## SERVICE INSTRUCTION no. 2012/4 – revision 1

### Reduction of condensate water at Ignis burner

Fig 1 – Jets to be replaced

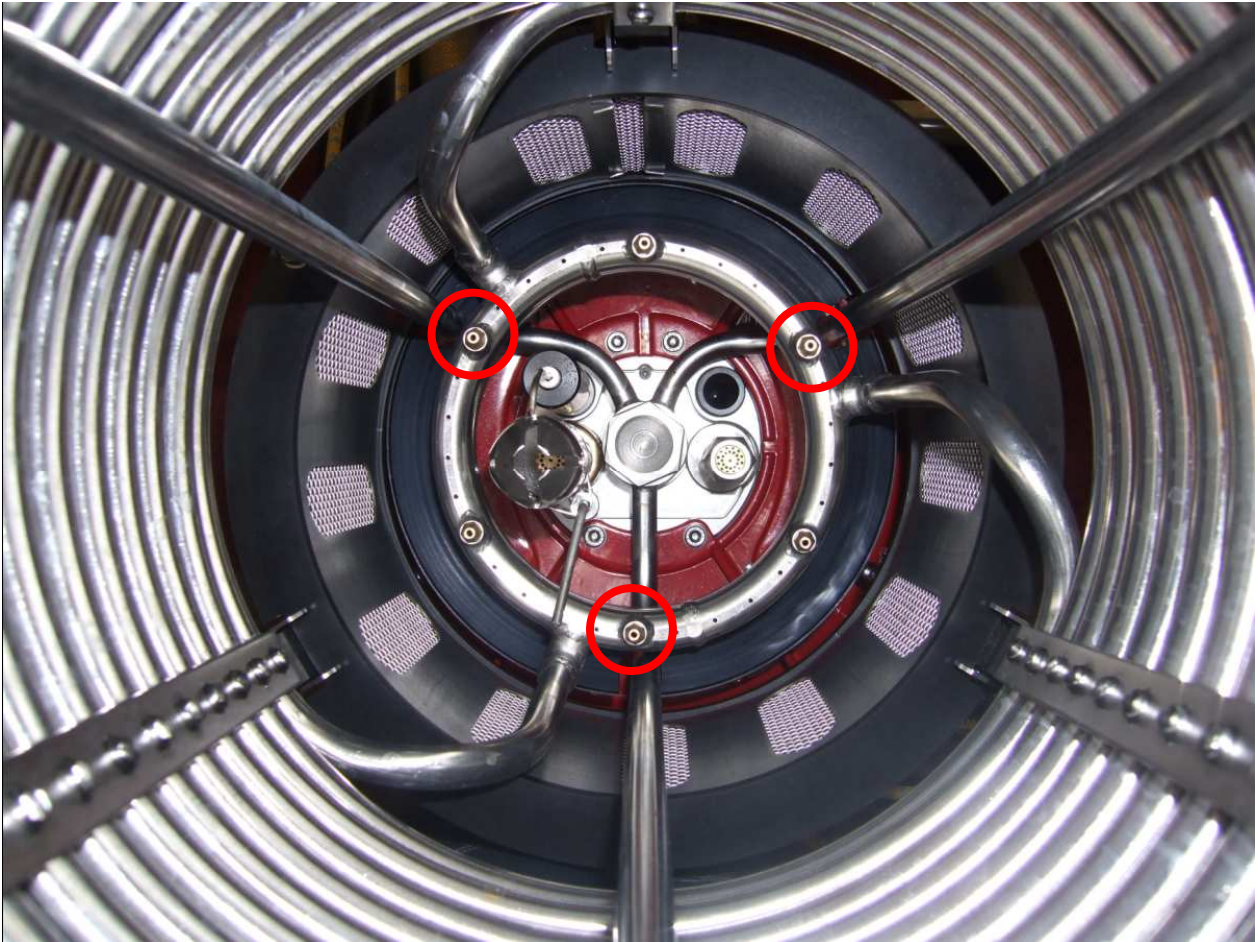
- With reference to:** Burner units of serial numbers from 598
- Reason:** Operation of Ignis burner using pure propane pressurised close to maximum pressure can cause increased generation of condensate water
- Solution:** Propane flow through coil to be reduced using 1 – 6 blind jets instead of standard jets supplied with the burner. Replacing of 3 jets marked on fig 1 is a preferred option.

1. Unscrew the jet(s) using wrench key, size 6 (Fig 1)
2. Replace the jet(s) with the blind jet (part no. 54255.00; Fig 2)
3. Fix the blind jet thread using Loctite 620 (part no. 3122.00)
